Addendum No. 2 (2 pages total)

Project: Goddard School – Darien, Illinois
Project number: 2011.0321

Architect: Interplan LLC: 1 S 280 Summit Ave. Oakbrook Terrace, IL 60181
Tel) 630-932-2336, Fax) 630-932-2339

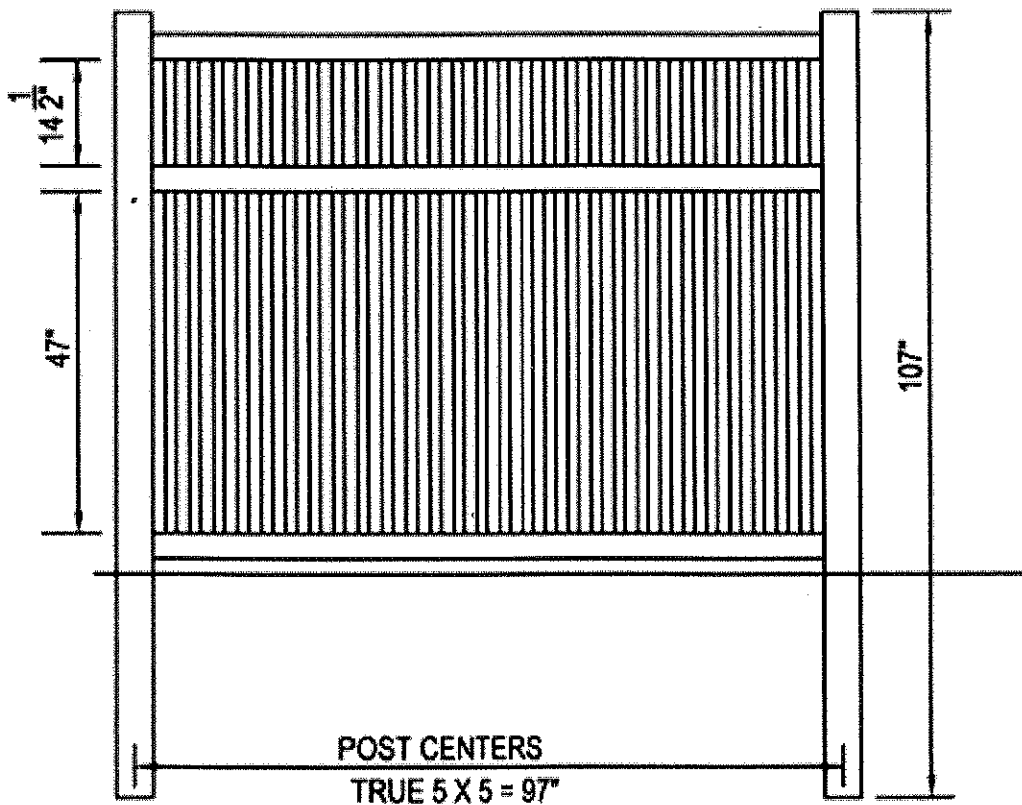
1. **Project** –The Project is not required to be 100% union. The Owner is requiring the electrical and plumbing trades to be union.
2. **Structural Framing** – The notes on the structural drawings take precedent over Specification Section 06 10 00 and 06 17 53.
3. **West Retaining Wall** – The difference in grade from the west side of the retaining wall to the east side is 1'-0".
4. **Vinyl Fencing** – The vinyl fencing should be Certainteed Bufftech fencing or equal with a lifetime warranty, see attached cut sheet. The vinyl fencing posts should be set in concrete foundations as per manufacturer's installation instructions.

The frost walls for the doors on the north side of the building should extend out from the building 4'-6" in lieu of 5'-0" to allow room for the installation of the fence post. The fence posts can be installed prior to the sidewalk pour or core drilled after the sidewalk pour.

The fence on the west side of the building should be installed on the high side (east) of the retaining wall.
